AGENDA

NFPA Technical Committee on Inspection, Testing, and Maintenance of Water-Based Systems (INM-AAA) NFPA 25 Second Draft Meeting (A2025)

DRAFT MINUTES

NFPA Technical Committee on Inspection, Testing, and Maintenance of Water-Based Systems (INM-AAA) NFPA 25 First Draft Meeting (A2025)

Figure A.5.3.4 Isothermal Lines — Lowest One-Day Mean Temperature (°F).

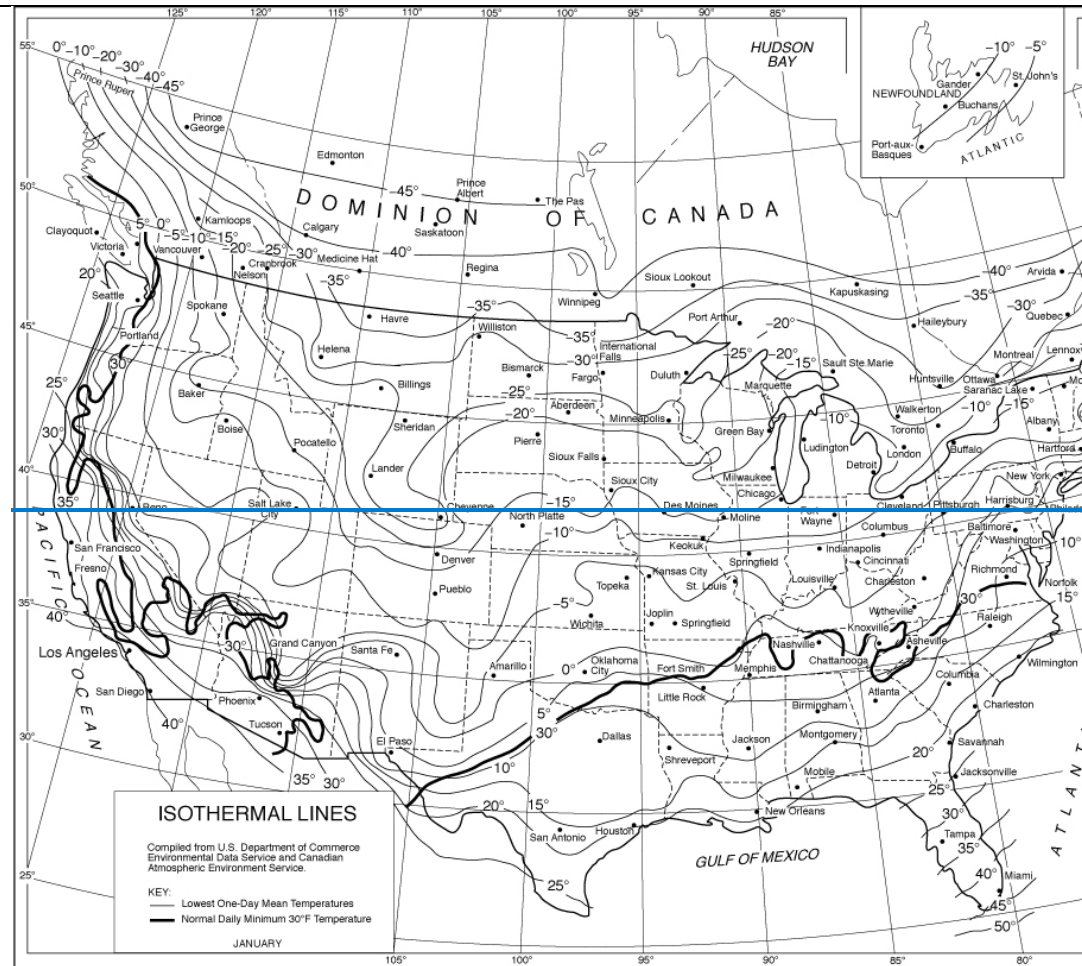
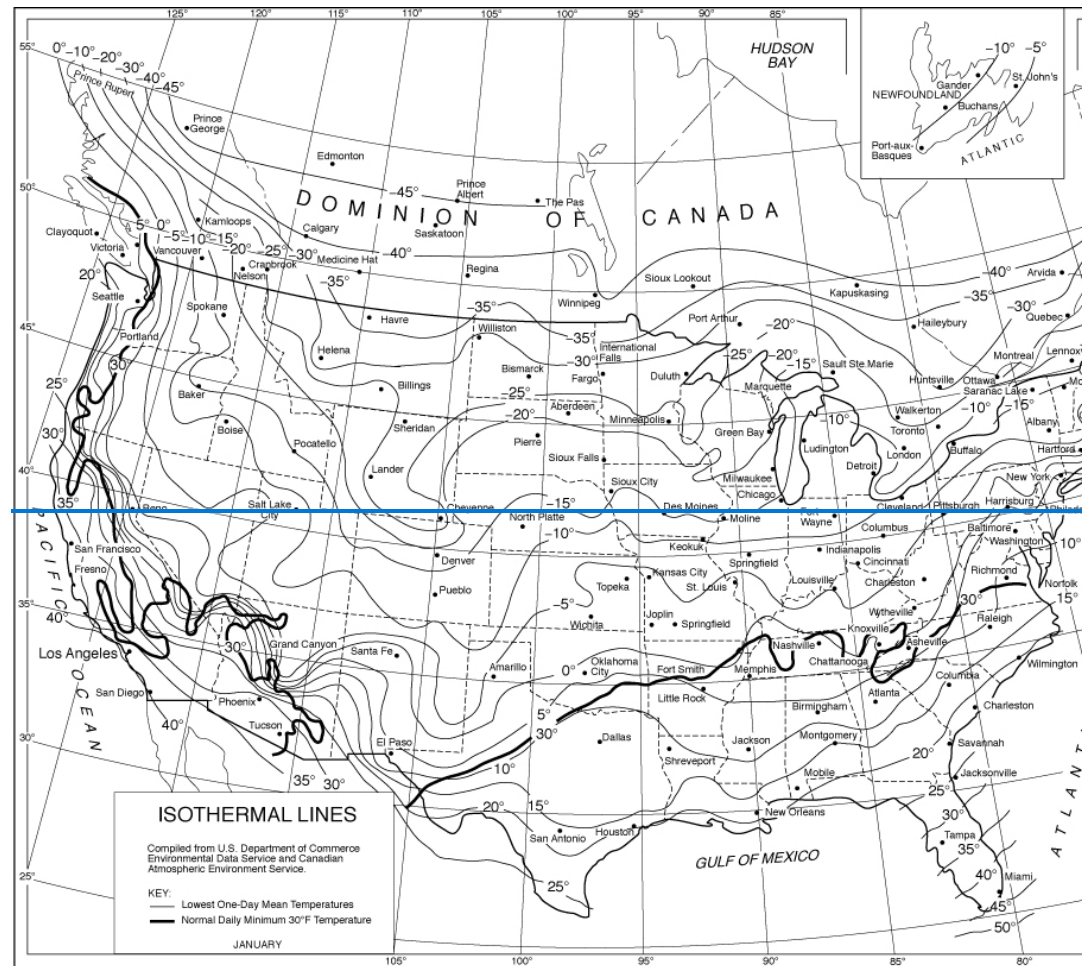
Section	PI	PAGE	DISPOSITION
A.5.3.4	99		Create a first revision based on PI 99
Proposed Text (PI)	A.5.3.4 Sampling from the top and bottom of the system helps to determine if the solution has settled. Antifreeze solutions are heavier than water. If the antifreeze compound is separating from the water due to poor mixing, it will exhibit a higher concentration in the lower portion of the system than in the upper portion. If the concentration is acceptable near the top, but too low near the water connection, it might mean the system is becoming diluted near the water supply. If the concentration is either too high or too low in both the samples, it might mean the wrong concentration was added to the system. Two or three times during the freezing season, test samples can be drawn from Valve B as shown in Figure 8.6.3.1 of NFPA 13, especially if the

~~See Figure A.5.3.4 for expected minimum air temperatures in 48 of the United States and parts of Canada where the lowest one-day mean temperature can be used as one method of determining the minimum reasonable air temperature. In situations where the piping containing the antifreeze solution is protected in some way from exposure to the outside air, higher minimum temperatures can be anticipated.~~

~~Figure A.5.3.4 Isothermal Lines — Lowest One-Day Mean Temperature (°F).~~

(5) Other approved sources [13, A.16.4.1.1.1]
Committee Text (FR)	A.5.3.4 Sampling from the top and bottom of the system helps to determine if the solution has settled. Antifreeze solutions are heavier than water. If the antifreeze compound is separating from the water due to poor mixing, it will exhibit a higher concentration in the lower portion of the system than in the upper portion. If the concentration is acceptable near the top, but too low near the water connection, it might mean the system is becoming diluted near the water supply. If the concentration is either too high or too low in both the samples, it might mean the wrong concentration was added to the system. Two or three times during the freezing season, test samples can be drawn from Valve B as shown in Figure 8.6.3.1 of NFPA 13, especially if the water portion of the system has been drained for maintenance or repairs. A small hydrometer can be used so that a small sample is sufficient. Where water appears at Valve B, or where the sample indicates that the solution has become weakened, the entire system should be emptied and refilled with acceptable solution as previously described. ~~See Figure A.5.3.4 for expected minimum air temperatures in 48 of the United States and parts of Canada where the lowest one-day mean temperature can be used as one method of determining the minimum reasonable air temperature. In situations where the piping containing the antifreeze solution is protected in some way from exposure to the outside air, higher minimum temperatures can be anticipated.~~ Where systems are drained in order to be refilled, it is not typically necessary to drain drops. Most systems with drops have insufficient volume to cause a problem, even if slightly higher concentration solutions collect in the drops. For drops in excess of 36 in. (915 mm), consideration should be given to draining drops if there is evidence that unacceptably high concentrations of antifreeze have collected in these long drops. ~~When emptying and refilling antifreeze solutions, every attempt should be made to recycle the old solution with the antifreeze manufacturer rather than discard it.~~

(4) American Society of Heating, Refrigerating and Air-Conditioning Engineers (ASHRAE) (5) Other approved sources [13, A.16.4.1.1.1]
Statement	It is no longer appropriate to recycle non-listed antifreeze and this added language correlates with NFPA 13 and NFPA 24.
